Prospect Point South
Superior Township, Michigan

Presentation to the Planning Commission

ITEM TITLE: Timber Creek Flats Area Plan Petition

**Area Plan Review
For
Superior Township, Michigan**

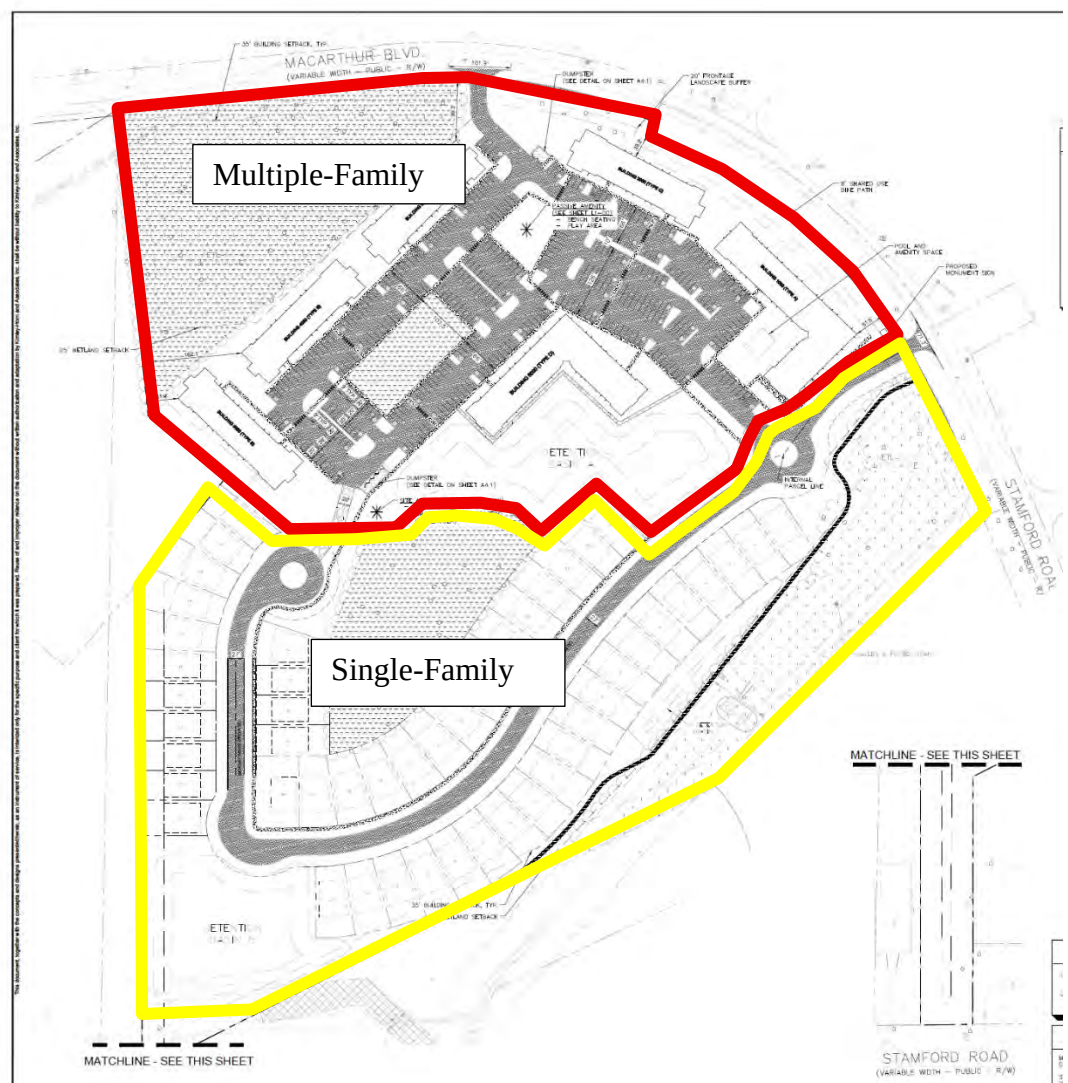
The concept plan reviewed by the Planning Commission in December included a mix of 46 townhome units. We found that the inclusion of the townhomes provided an additional housing component and broke up the massing of the overall development, especially as frontage McArthur Boulevard.

We encourage the reintroduction of the townhome units.
